Access Compliance Report

Public Rights-of-Way

(Pedestrian Signals)

Intersection ID: N/A	Main Street:	Cross Street: N/A	Location: N/A
ADA ID: 01C1AB735F91	Signal Type: One Push Button-Non APS	Overall Compliance: No	Severity Score: BTN 1: N/A BTN 2: N/A No BTN: N/A
Codes/Mitigation Info/Possible Solution		Field Measurements/Component Compliance

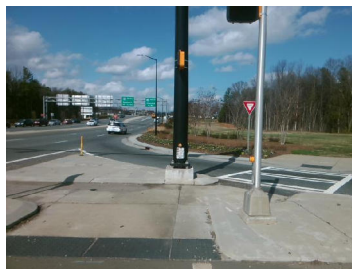
PROW/ADA: R404.2, R404.7.3, R404.7.2

N/A	B 1 FWD Approach Width (in)	N/A	N/A	B 2 FWD Approach Width (in)	N/A
N/A	B 1 FWD Approach Obstruction?	Yes	N/A	B 2 FWD Approach Obstruction?	N/A
N/A	B 1 FWD Approach Obstruction Dist (in)	3.0	N/A	B 2 FWD Approach ObstructionDist (in)	N/A
N/A	B 1 PARA Approach?	Yes	N/A	B 2 PARA Approach?	N/A
N/A	B 1 PARA Approach Constrained?	Yes	N/A	B 2 PARA Approach Constrained?	N/A
No	B 1 PARA Approach Reach (in)	40.0	N/A	B 2 PARA Approach Reach (in)	N/A
No	B 1 PARA Approach Width (in)	48.0	N/A	B 2 PARA Approach Width (in)	N/A
N/A	B 1 PARA Approach Obstruction?	Yes	N/A	B 2 PARA Approach Obstruction?	N/A
N/A	B 1 PARA Approach Obstruction Dist (in)	4.0	N/A	B 2 PARA Approach ObstructionDist (in)	N/A
Yes	B 1 Clear Floor Space Slope (%)	0.8	N/A	B 2 Clear Floor Space Slope (%)	N/A
No	B 1 Clear Floor Space XSlope (%)	4.0	N/A	B 2 Clear Floor Space XSlope (%)	N/A
N/A	B 1 PAR Slope (%)	N/A	N/A	B 2 PAR Slope (%)	N/A
Yes	B 1 Height (in)	41.0	N/A	B 2 Height (in)	N/A

Possible Solutions: Remove and Replace Clear Space.
